RISO INC. **TECHNICAL INFORMATION BULLETIN**

Subject: New Style Drum PCB | Bulletin No: 38

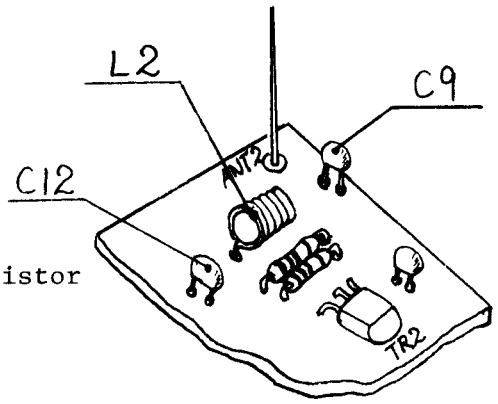
Problem: No Ink supplied to drum

Cause: 1) Bad solder connection on Ant-2
2) Position of coil L2
3) Antenna sensitivity

Problem: T4 too much ink supplied to drum

1) Antenna sensitivity

Correct

Incorrect

Check Solder

Incorrect

Solution: 1) Resolder Antenna
2) Reposition/reform L2, C9, C12
3) Replace R14 on drum PCB to 33KR Resistor

Solution: 1) Replace R14 drum PCB with 27KR resistor
2) Reposition/reform L1, C2, C5
